NOTICE EXPIRED – RECLAMATION REQUIREMENTS INCOMPLETE

The Western Union Corporation Notice, COC-074166 to conduct uranium exploration drilling located in Fremont County, T. 17 S., R. 73 W., section 27, expired on October 10, 2020. A final inspection was conducted on August 25, 2020 (Enclosure 1) and BLM determined all reclamation requirements for bore hole abandonment (bore hole and drill pad number Hndd010) had been met; however, Class A noxious weeds (i.e., thistles) and erosion along the reclaimed access road were present. Per 43 CFR 3809.335(b), all reclamation obligations continue beyond the expiration of the Notice, until reclamation has been satisfied.

Minerals Exploration/Sampling/Testing Inspection

Image 3: (Image taken by J. Elkington, 08/25/20)

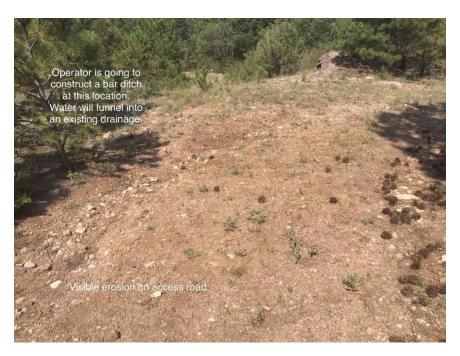
Comment: Adequate revegetation on access road near drill pad/site number (Hndd010). Growth of grasses, yarrow, and voluntary ponderosa pine. Viewed to the west.
